Development Services Staff Report

File Number	PL2025-340
File Name	PRELIMINARY DEVELOPMENT PLAN – John Knox Village – Country Club Corridor Hybrid Villas
Applicant	SFCS, Inc
Property Address	Southeast corner of NW Chipman Road & NW Pryor Road
Planning Commission Date Heard by	April 9, 2026 Planning Commission and City Council
Analyst	Adair Bright, AICP, Senior Planner

Figure 4 – Site Plan showing angled head-in parking

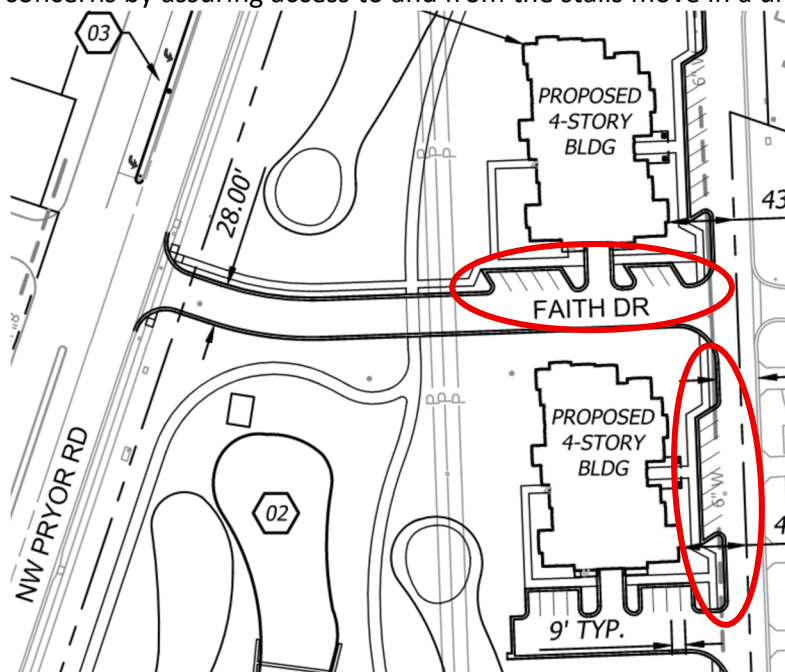
1. The applicant has requested a modification to UDO Sec. 8.620.A – Parking Lot Design, Head-In Parking
 - **Requirement** – Head-in parking from any public right-of-way or private street shall not be permitted, except that the use of head-in parking in the downtown area may be considered on a case-by-case basis.
 - **Proposed** – The applicant is proposing head-in angled parking on NW Faith Drive and NW Shamrock Ave.
 - **Staff Recommendation** – Staff is supportive of the proposed modification as head-in angled parking is an existing condition elsewhere in John Knox Village and is being provided to meet the required quantity of parking stalls as required by the UDO. The angled stalls minimize safety concerns by assuring access to and from the stalls move in a uniform direction.

1. Development shall be in accordance with the preliminary development plan with an upload date of March 20, 2026.
2. A modification shall be granted to UDO Sec. 8.620.A to allow for angled head-in parking from NW Faith Drive and NW Shamrock Avenue.
